TUAM HISTORIC LANDFILL - H0192-01

Response To Request For Information

Prepared for:
Galway County Council

| | | | | Drawn by | SK | Drawing Number | P22-065-0600-0001 |

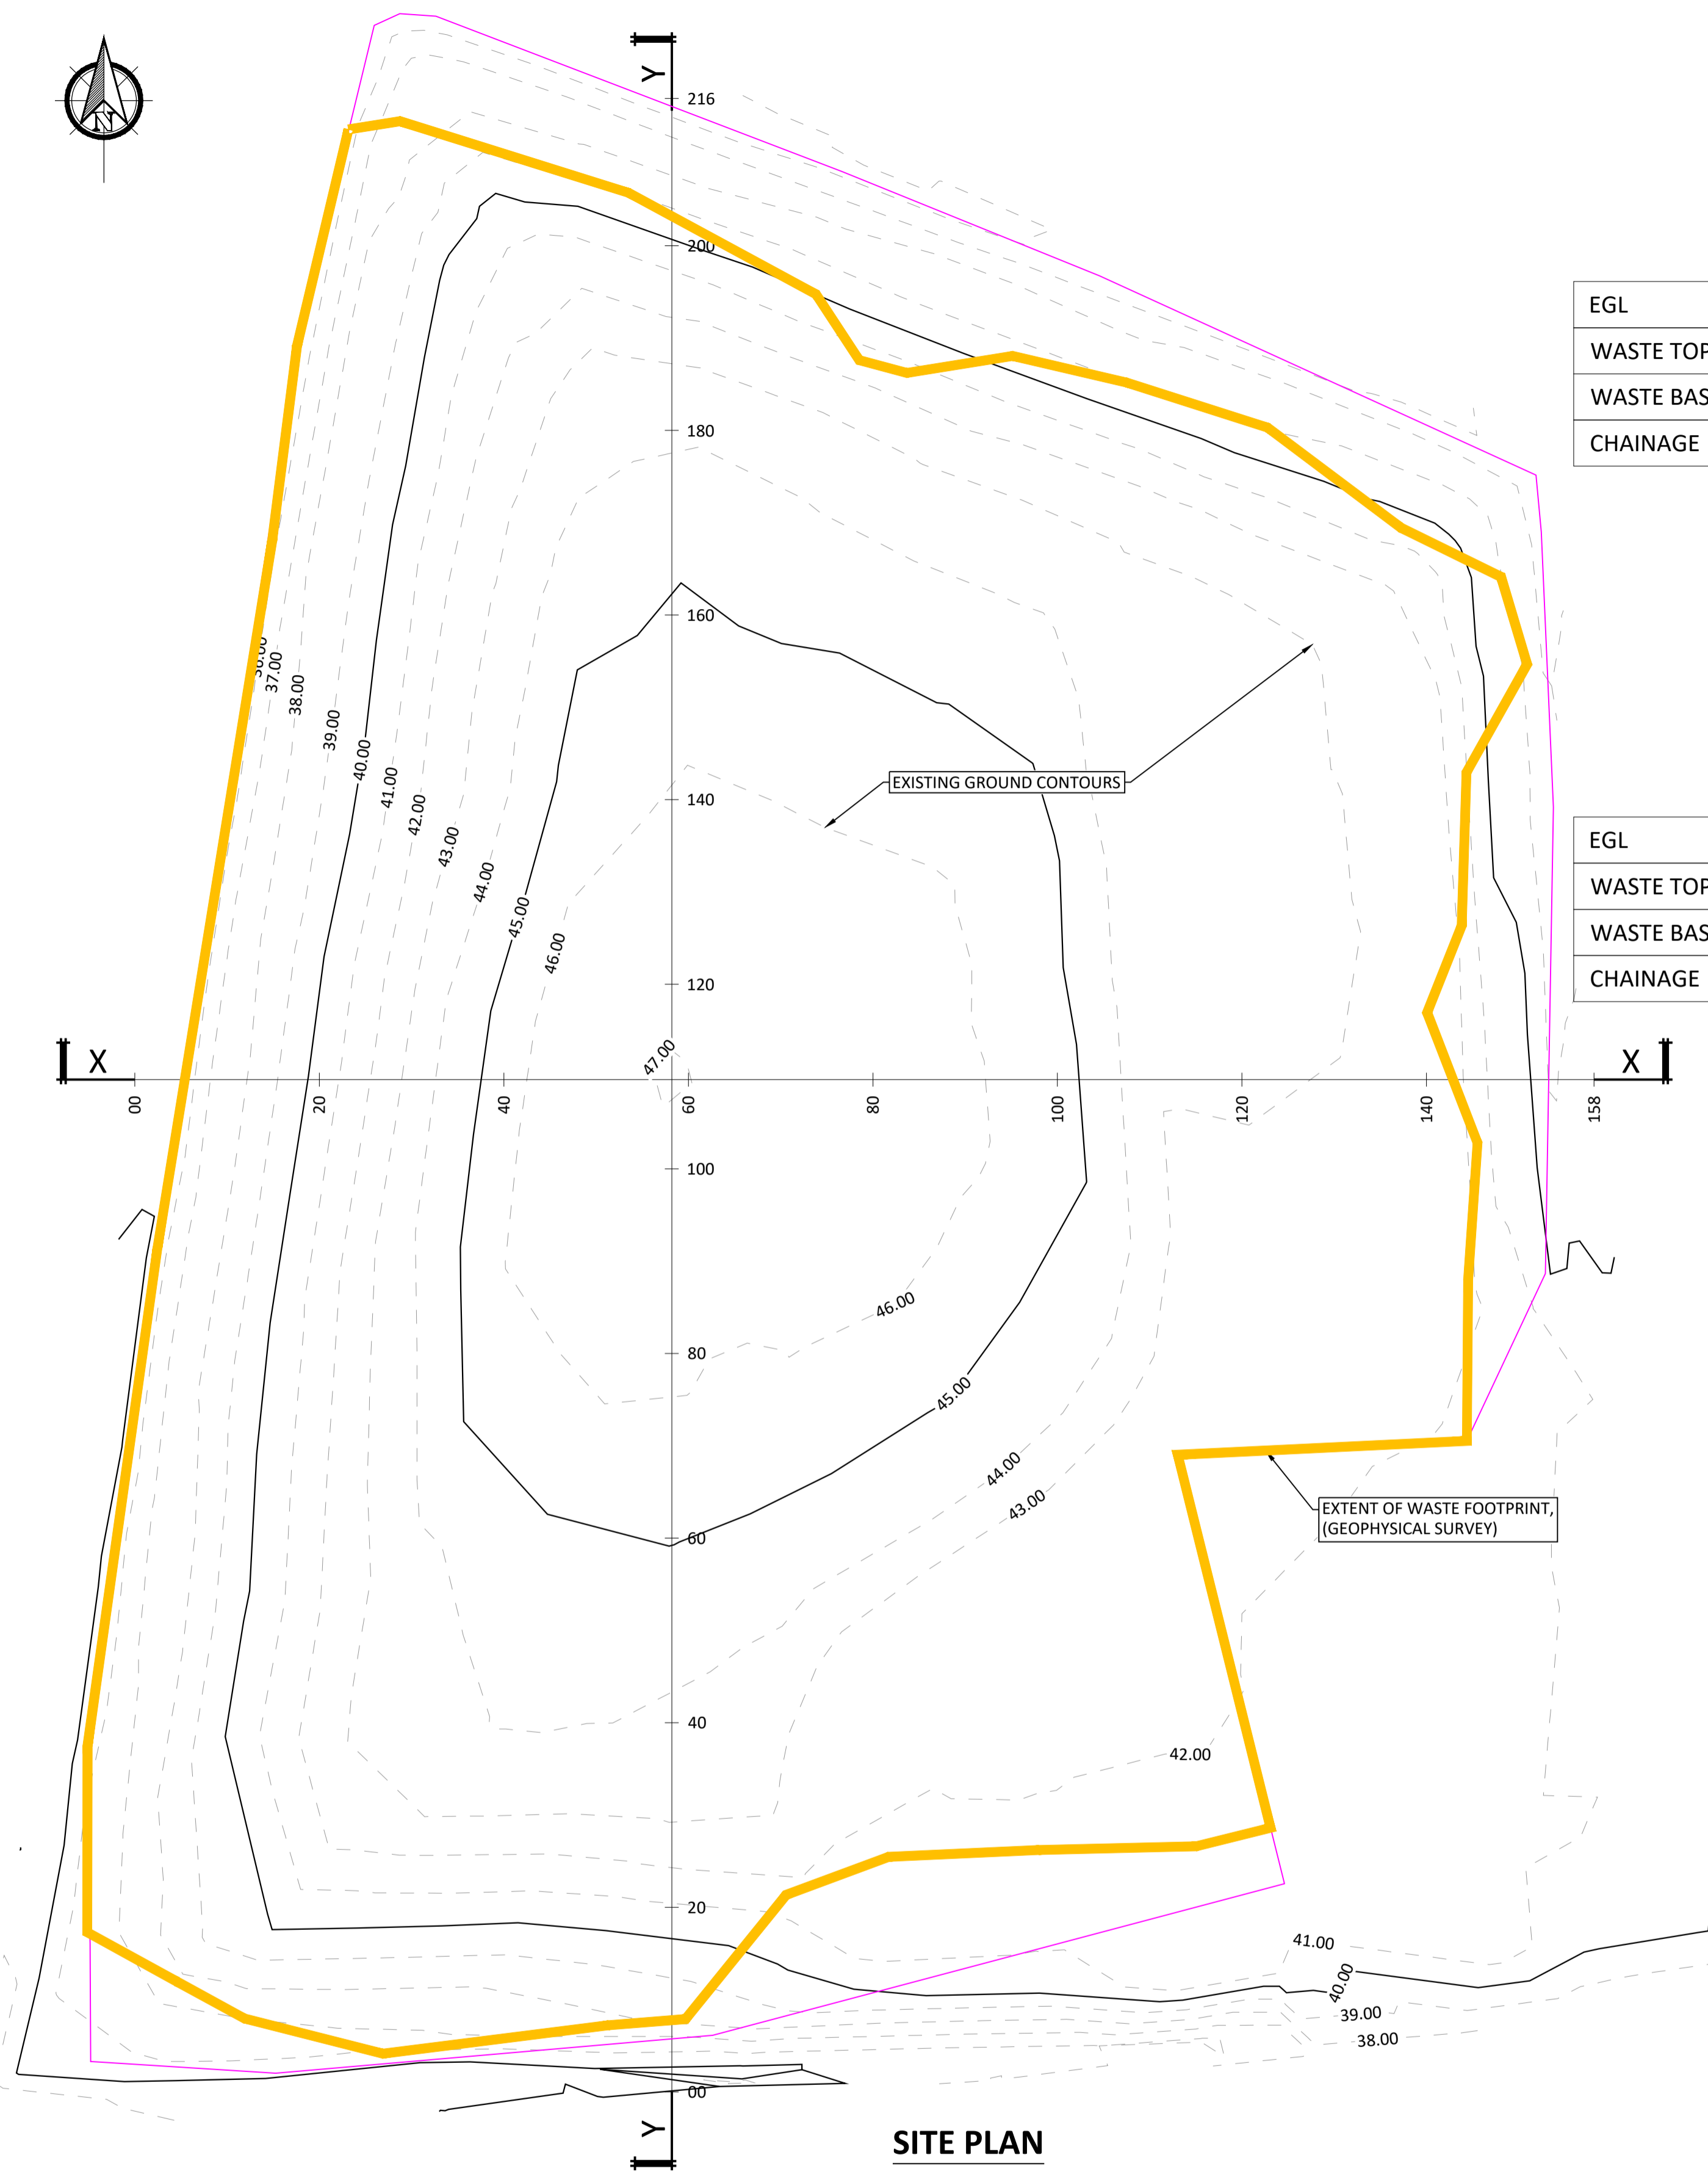
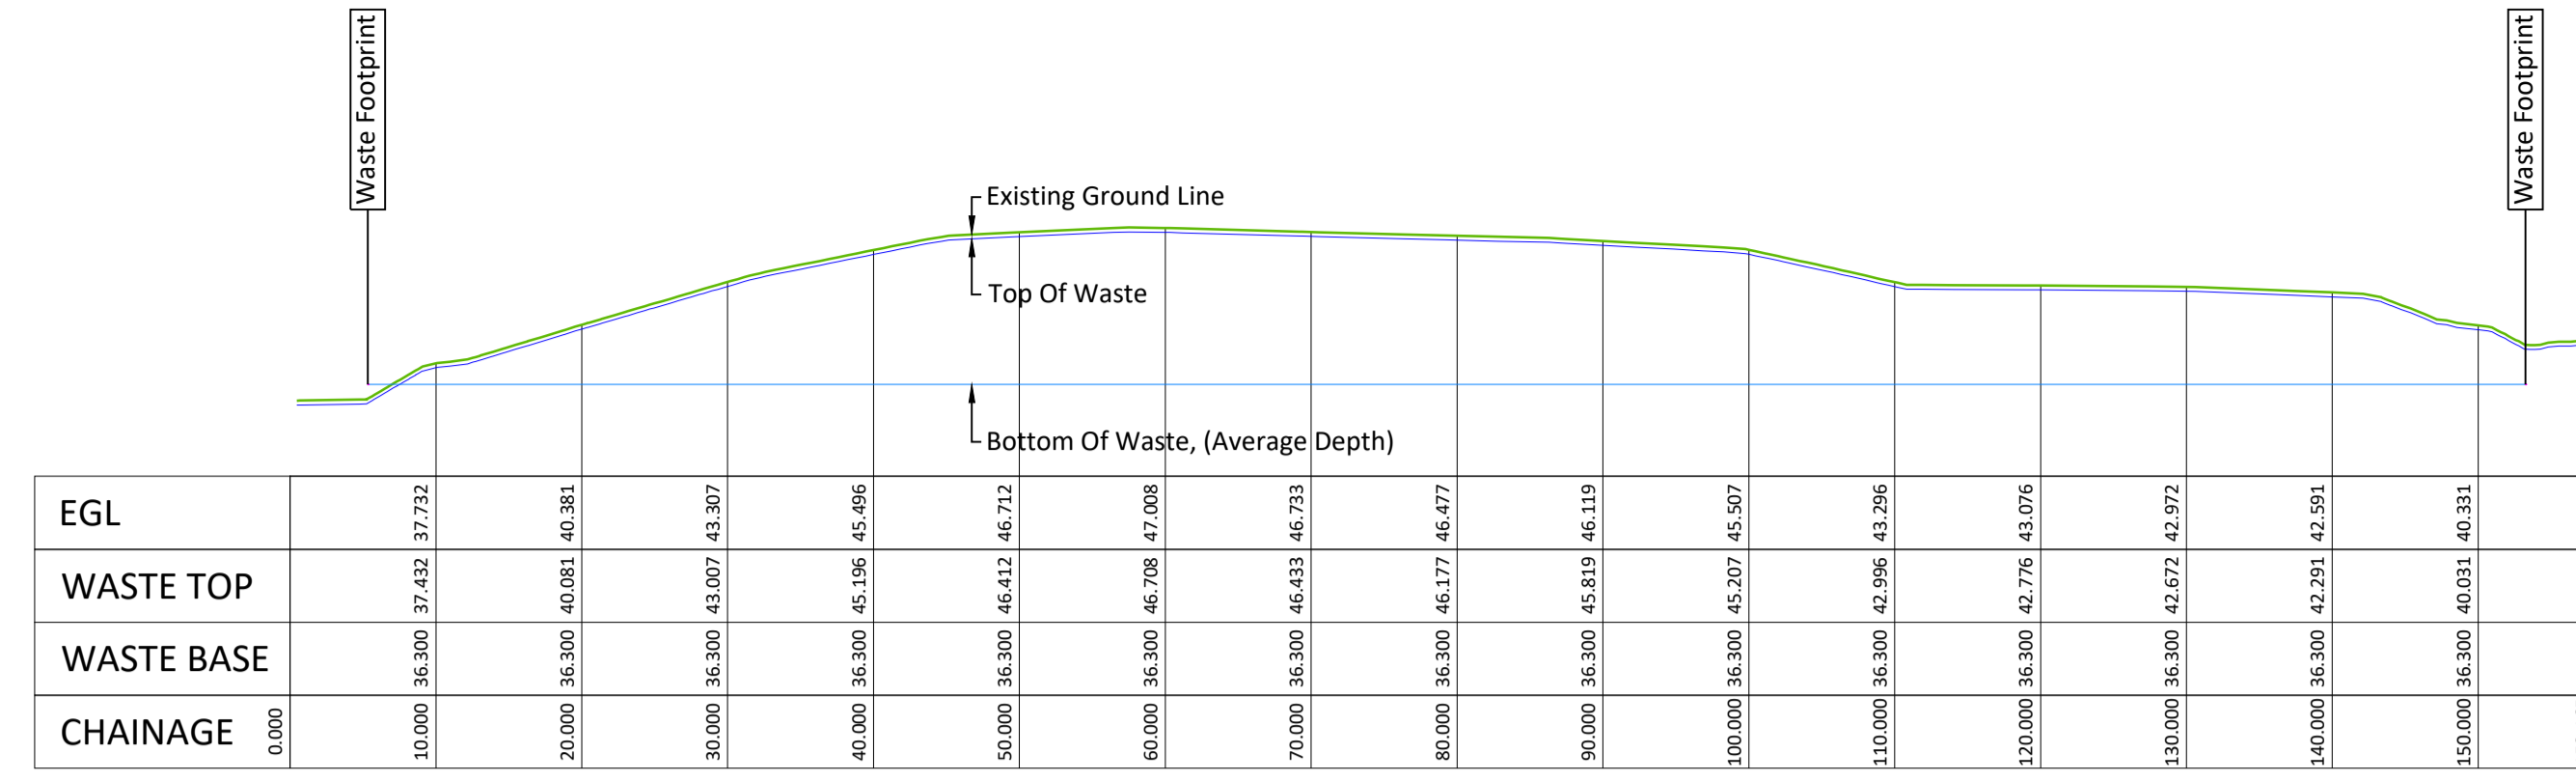
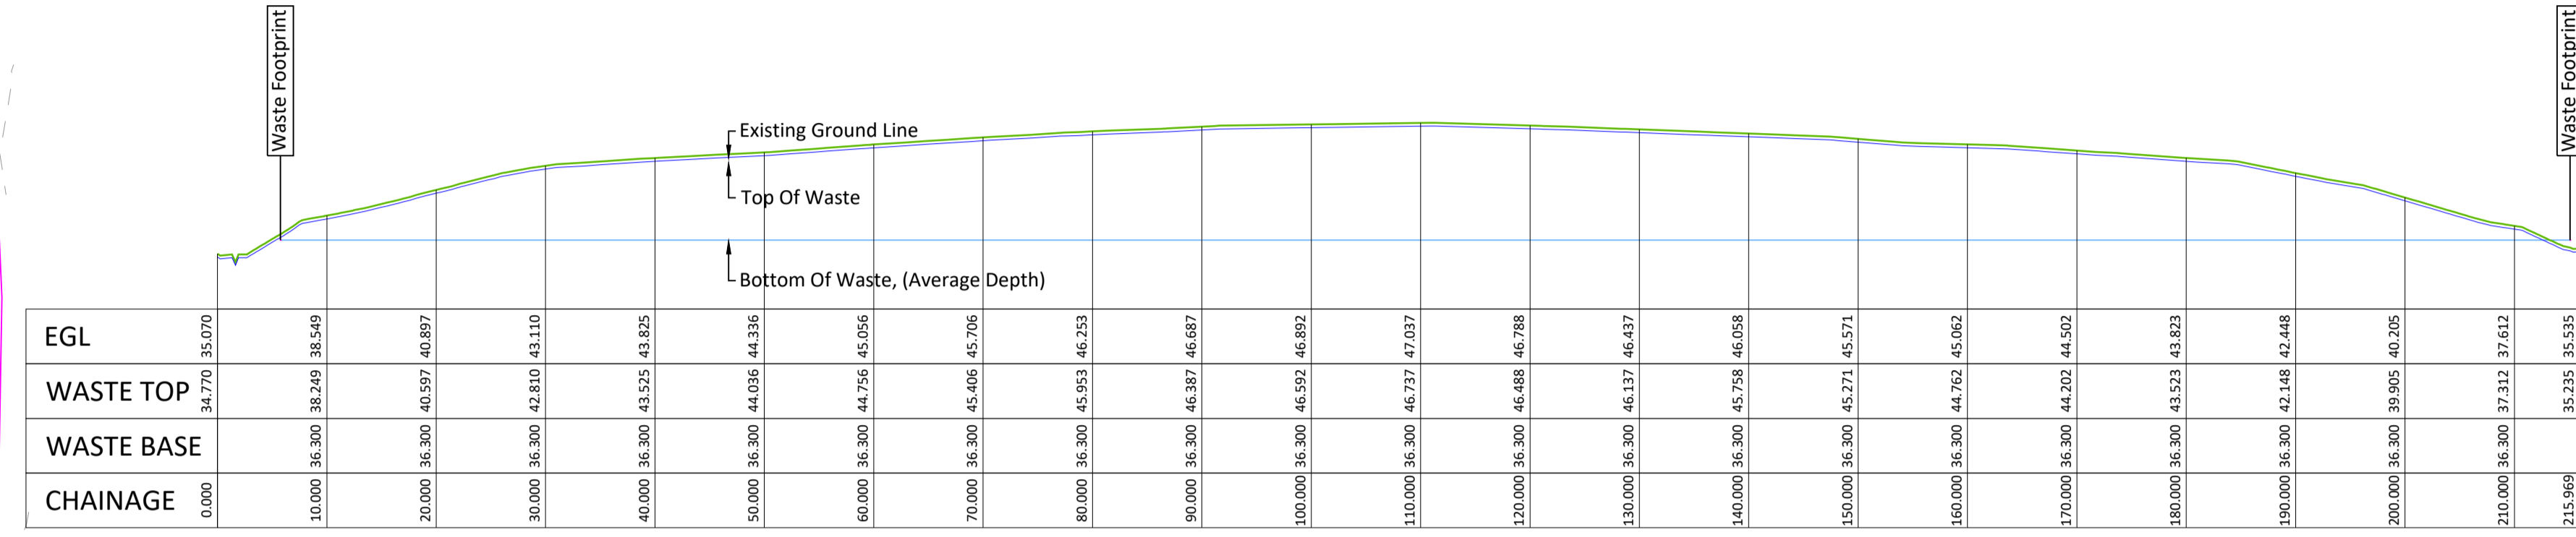
Section 1.3 of the Tier 3 Assessment estimates that 274,784 tonnes to 354,560 tonnes of waste was deposited on site, a difference of 79,776 tonnes. Provide a more precise estimation of the amount of waste deposited. Please also include the volume for the total amount of deposited waste in m³.

AutoCAD Civil 3D was used to estimate of the total volume of waste deposited at the site. A 3D model was prepared using the following information: 2020 topographical survey (See Appendix 4 of the Tier 2 report), 2020 geophysical surveys (See Appendix 5 of the Tier 2 report) and results of the additional 2022 site investigation works (See Appendix 8 of this report).

The volume was calculated using the existing ground level from the topographical survey (excluding the 300mm of capping material); the area of waste from the geophysical survey and the average base level of waste obtained in the last site investigation, in July 2022 (Appendix 8).

The total estimated volume of waste for Tuam Historic Landfill is 145,407.7 m³, applying an assumed waste density of 1.6 t/m³ equates to 232,652 tonnes of waste present.

The results of the updated waste volume calculation are presented in Drawing No. P22-065-0600-0001 below.

Figure No. 1.1 'Site Location'

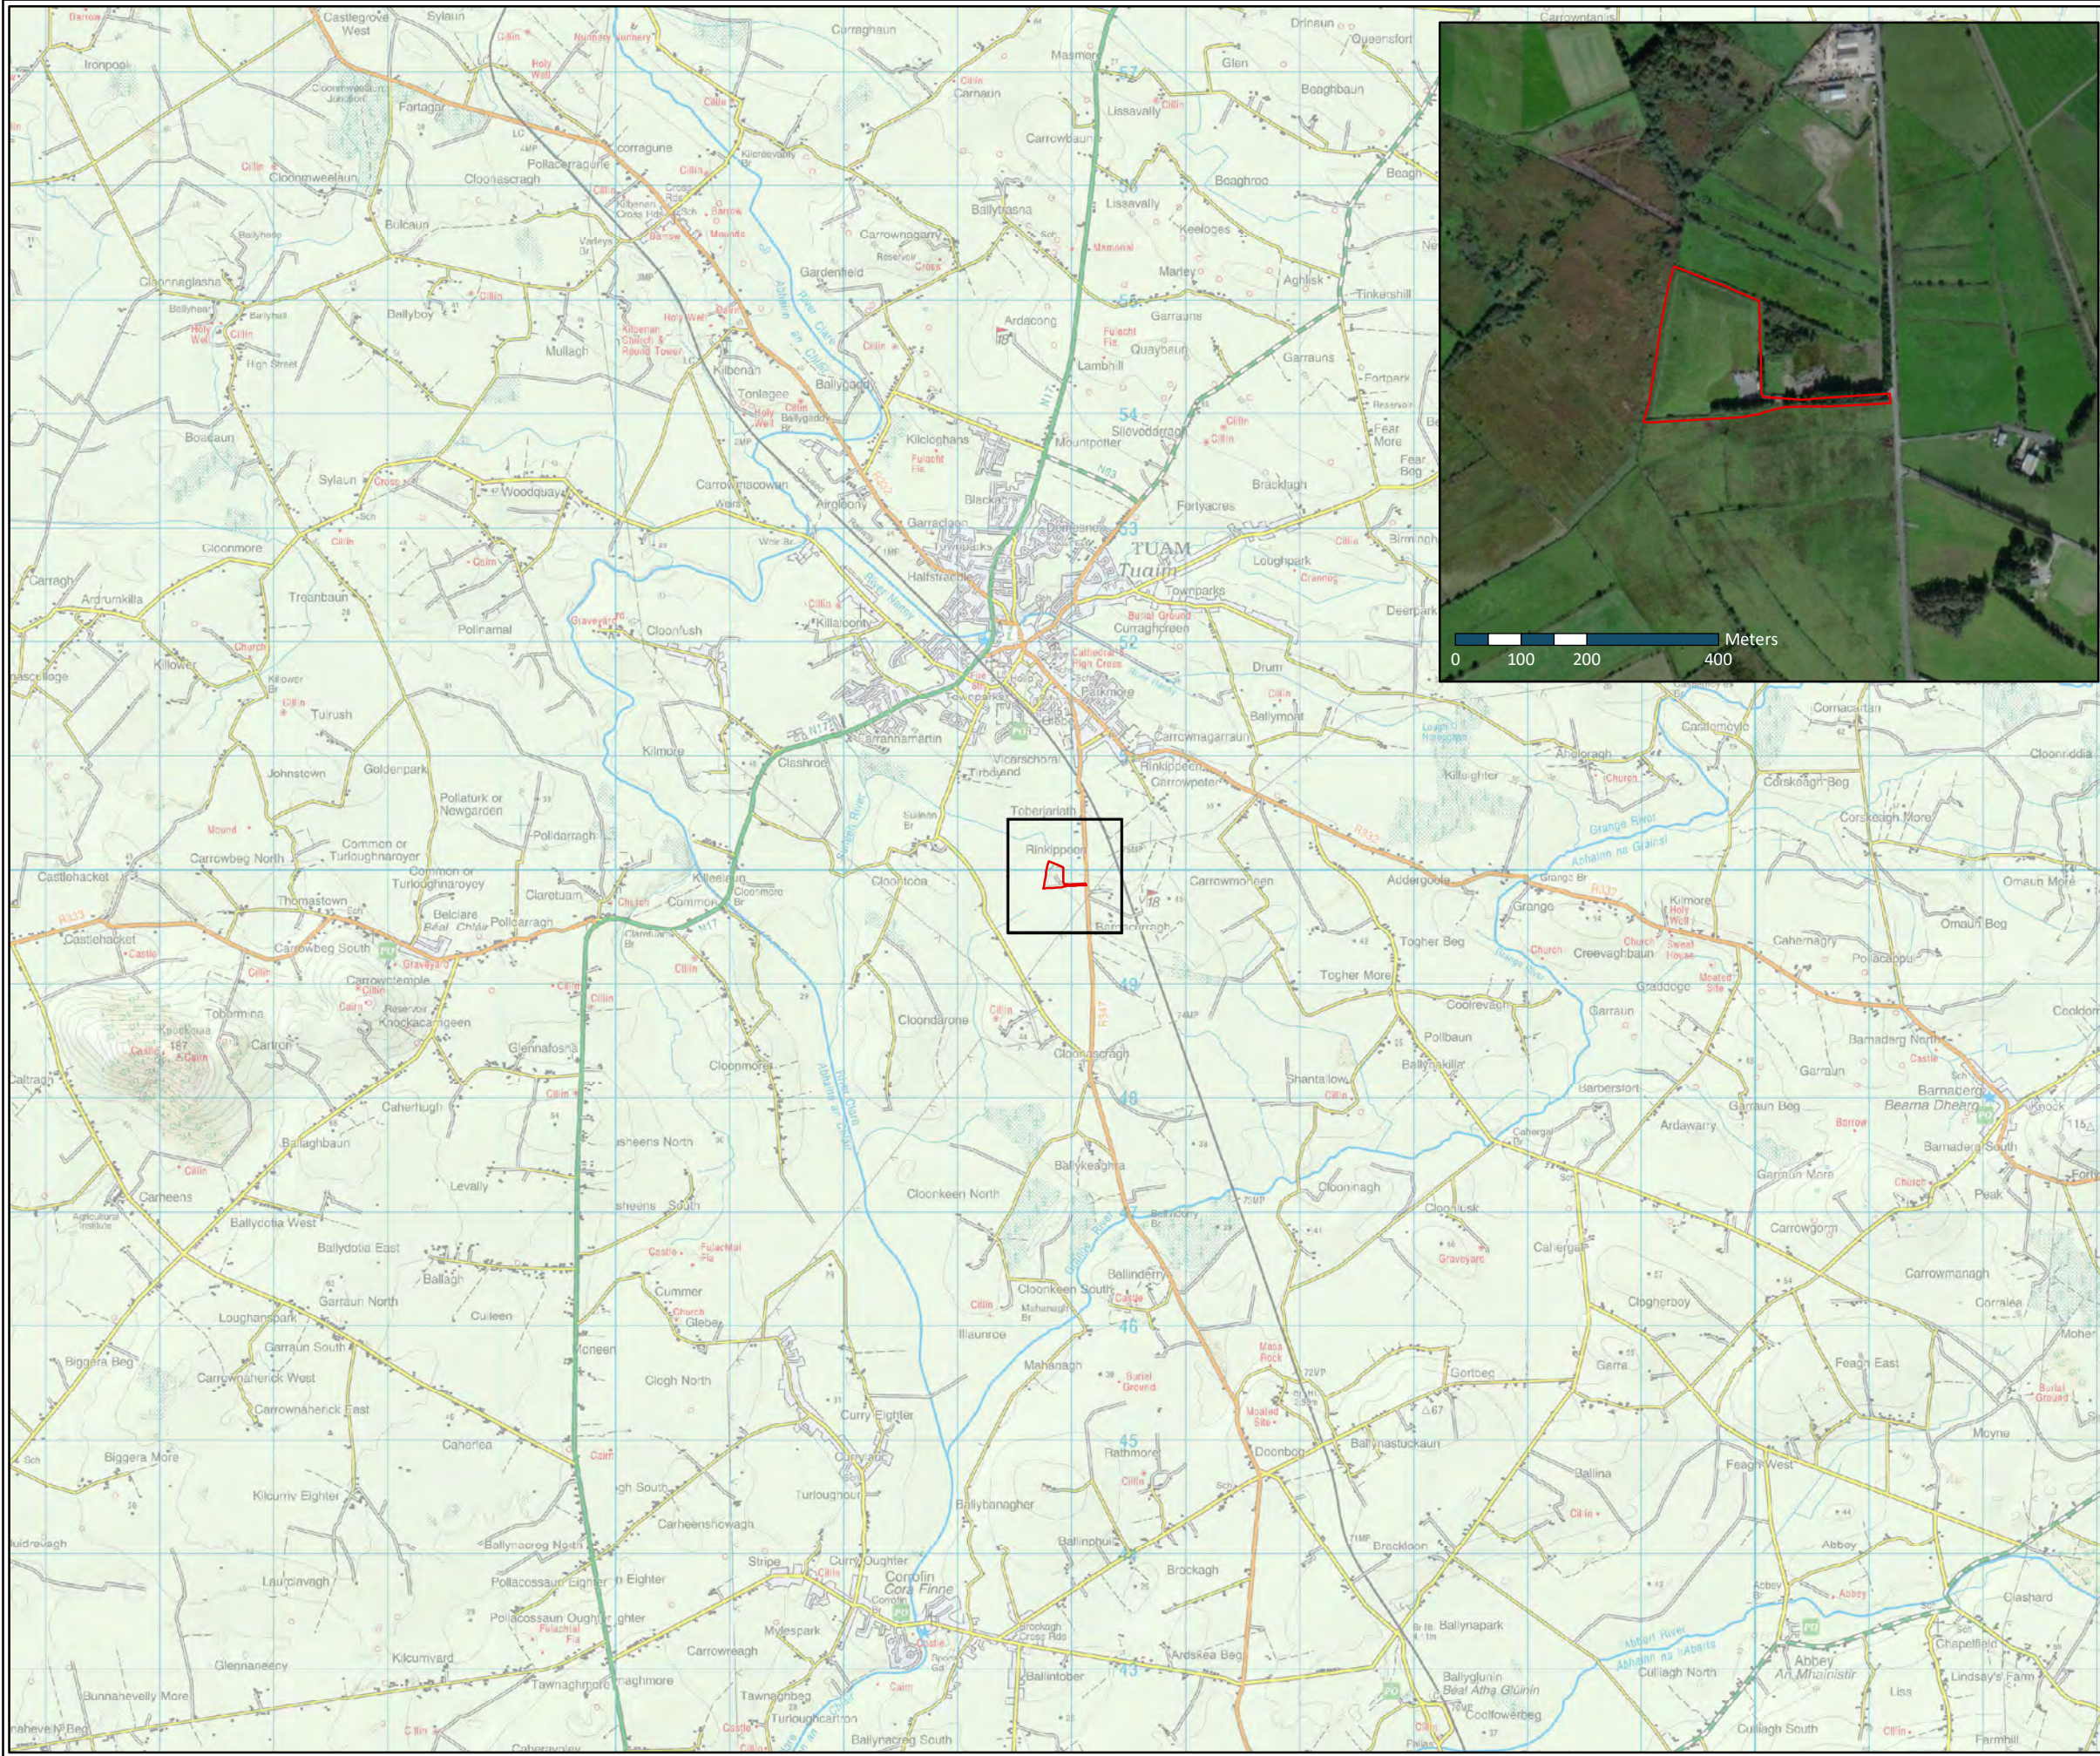
The site boundary shown in Figure No. 1.1 'Site Location' dated 18/10/2021 of the application and in Figure (no figure number given) titled 'Site Location Plan' dated 21/09/2020 of the Geotechnical Report differ. State the reason for the differences in the extent of the site boundary in said figures and submit, or refer to, a figure that shows the actual site boundary.

The site boundary shown in Figure (no figure number given) titled 'Site Location Plan' dated 21/09/2020 of the Geotechnical Report was initially assumed as the site boundary. The site boundary was updated after site investigations were undertaken and is reflected as per Figure No. 1.1 'Site Location' dated 18/10/2021, this is the correct site boundary.

The definitive site boundary can be found in Figure No. 1.1 'Site Location', Appendix 3 of this report.
